Access Compliance Report

Public Rights-of-Way

(Curb Ramps)

Intersection ID: 50589	Main Street: BENDING_BRANCH_RD	Cross Street: GREEN_GRASS_RD	Location: NW
ADA ID: 1BFE67B5A1F0	Ramp Type: Perp	Initial Pass/Fail: Fail	Overall Compliance: No
		Severity Score: 10

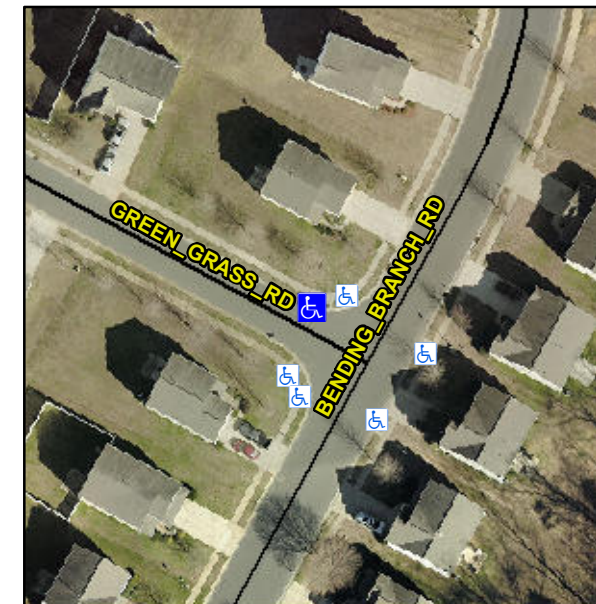
Not Found, R304.5.1, R304.5.3

Compliance	Description	Data	Compliance	Description	Data
N/A	Ramp Length (in)	47.5	Yes	Ramp Slope (%)	6.0
No	Ramp Width (in)	47.0	No	Ramp XSlope (%)	4.5
N/A	Flare Type LT	N/A	N/A	Flare Type RT	N/A
N/A	Flare Slope LT (%)	N/A	N/A	Flare Slope RT (%)	N/A
N/A	Flare Traversable LT?	N/A	N/A	Flare Traversable RT?	N/A
N/A	Landing Length (in)	N/A	N/A	DWS Provided?	N/A
N/A	Landing Width (in)	N/A	N/A	DWS Contrast?	N/A
N/A	Landing Slope (%)	N/A	N/A	DWS Length (in)	N/A
N/A	Landing X Slope (%)	N/A	N/A	DWS Full Width?	N/A
N/A	Landing Curb? (Y/N)	N/A	N/A	DWS Offset (in)	N/A
N/A	Shared Landing?	N/A			
N/A	Gutter Ponding?	N/A	N/A	Gutter Slope (%)	N/A
N/A	Gutter Lip Ht (in)	N/A	N/A	Gutter X Slope (%)	N/A
N/A	Painted X Walk1?	No	N/A	Painted X Walk2?	N/A
	X Walk 1 Direction	To SW		X Walk 2 Direction	N/A
N/A	X Walk 1 Width (in)	N/A	N/A	X Walk 2 Width (in)	N/A
	X Walk 1 Slope (%)	1.1		X Walk 2 Slope (%)	N/A
	X Walk 1 X Slope (%)	2.6		X Walk 2 X Slope (%)	N/A

Remove & Replace Entire Ramp.
